LARSON-ROGERS SUBDIVISION

Engineering Comments: FINAL PLAT COMMENTS (should be addressed prior to submitting the FINAL PLAT for review and/or signature by the City Engineer):

APPLICATION NUMBER 6 DATE November 2, 2017

DETAIL SITE PLAN

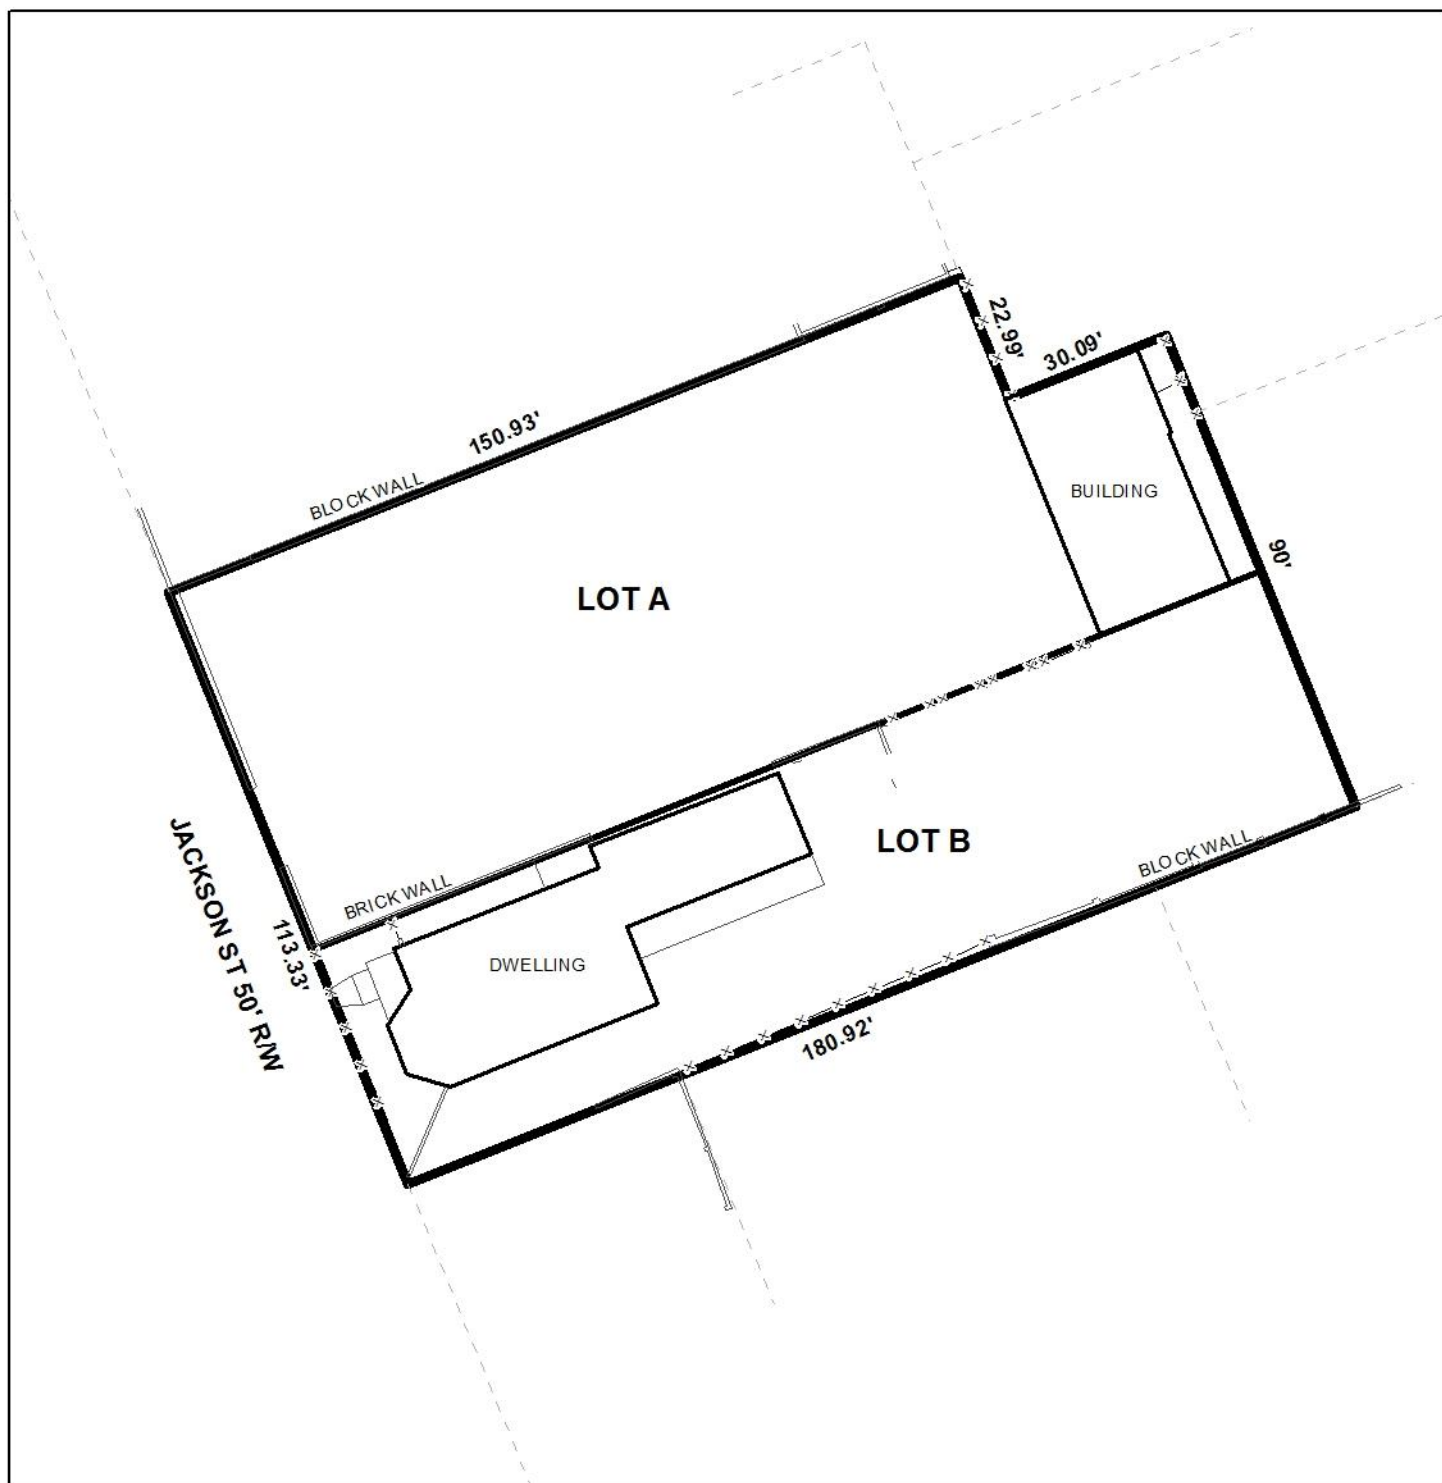
The proposed lots front North Jackson Street, a minor street with curb and gutter. As a minor street with curb and gutter, this street requires a minimum right-of-way width of 50 feet. The

right-of-way width is indicated as 50 feet on the preliminary plat, and should be retained as such on the Final Plat, if approved.

As previously stated the proposed lots are located within the Downtown Development District (DDD) and are zoned T-4. The DDD requires that primary structures in T-4 zoned districts have a maximum setback distance of 12 feet from the front property line. The 12-foot maximum building setback line is not depicted on the preliminary plat for the proposed lots, and should be revised on the Final Plat, if approved, with a waiver of Section V.D.9. of the Subdivision Regulations requiring a 25' setback.

Section 64-3.I.8.(b)(2) of the Zoning Ordinance requires newly platted properties in T-4 districts to be a minimum of 18 feet in width and a maximum of 120 feet in width. As proposed, Lot A will be 68± feet wide and Lot B be will 45± wide.

The proposed lots exceed the 7,200 square foot minimum lot size requirements for lots served by public water and sanitary sewer systems per the Subdivision Regulations. The lot size information is indicated in both acres and in square feet on the preliminary plat and should be retained on the Final Plat, if approved.

As a means of access management, a note should be placed on the Final Plat stating that each lot is limited to one curb-cut each to North Jackson Street, with any changes to the size, location and design to be approved by Traffic Engineering and conform to AASHTO standards.

- 1) Retention of the right-of-way width along North Jackson Street;
- 2) Revision of the site plan to depict a 12-foot maximum front building setback line;

- 3) Retention of the lot size information in both square feet and in acres;
- 4) Placement of a note on the Final Plat stating that each lot is limited to one curb-cut each to North Jackson Street, with any changes to the size, location and design to be approved by Traffic Engineering and conform to AASHTO standards;
